Access Compliance Report Public Rights-of-Way (Curb Ramps)

Main Street: LAKE COURT DR Cross Street: LOWER LAKE DR Location: E

ADA ID: RPRK211014112356 Ramp Type: Type 1 - Perpendicular Diagonal Initial Pass/Fail: Pass Overall Compliance: No Severity Score: 5

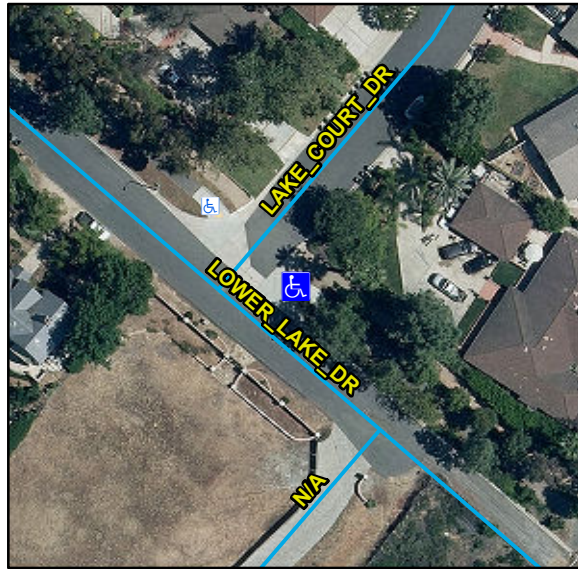
Compliance	Description	Data	Compliance	Description	Data
N/A	Ramp Length (in)	81	N/A	Flare Type LT	
Yes	Ramp Width (in)	48			Sloped
Yes	Ramp Run Slope (%)	0.8	N/A	Flare Slope LT (%)	17.6
Yes	Ramp Cross Slope (%)	2.5	N/A	Flare Traversable LT	No
N/A	Landing Present	Yes	N/A	Flare Type RT	
N/A	Landing Length (in)	105			Sloped
Yes	Landing Width (in)	48	N/A	Flare Slope RT (%)	1.9
No	Landing Run Slope (%)	6.4	N/A	Flare Traversable RT	No
Yes	Landing Cross Slope (%)	1.5	Yes	DWS Provided	Yes
N/A	Landing Movement Obstructed?	No	Yes	DWS Contrast	Yes
	Landing Movement Type	N/A	Yes	DWS Length (in)	36
N/A	Landing Shared	No	Yes	DWS Full Width	Yes
N/A	Clear Space	Yes	Yes	DWS Offset Left (in)	0
N/A	Clear Space To Crosswalk (in)	48	Yes	DWS Offset Right (in)	N/A
N/A	Marked Crosswalk 1	No	N/A	Marked Crosswalk 2	No
	Crossing 1 Direction	NW		Crossing 2 Direction	SW
	Marked Crosswalk 1 Width (in)	N/A		Marked Crosswalk 2 Width (in)	N/A

N/A	Ramp Inside Crosswalk 1	N/A	Yes	Ramp Inside Crosswalk 2	N/A
	Crossing 1 Slope (%)	6.1		Crossing 2 Slope (%)	1.5
	Crossing 1 Cross Slope (%)	3.4		Crossing 2 Cross Slope (%)	5.7
Yes	Gutter Ponding	No	Yes	Curb Slope	4.5
Yes	Gutter Lip Height (in)	0		Road Run Slope (%)	6.9
Yes	Gutter Run Slope (%)	1.2		Road Cross Slope (%)	0.9
No	Gutter Cross Slope (%)	6.7			
Yes	Overall Surface Condition: Acceptable		Yes	Perp Joint Present	Yes
	Cross Gutter Present?	Yes		Spandrel Present?	Yes
	Replace Cross Gutter?	No		Replace Spandrel?	No

Remove & Replace Landing. Remove & Replace Gutter.
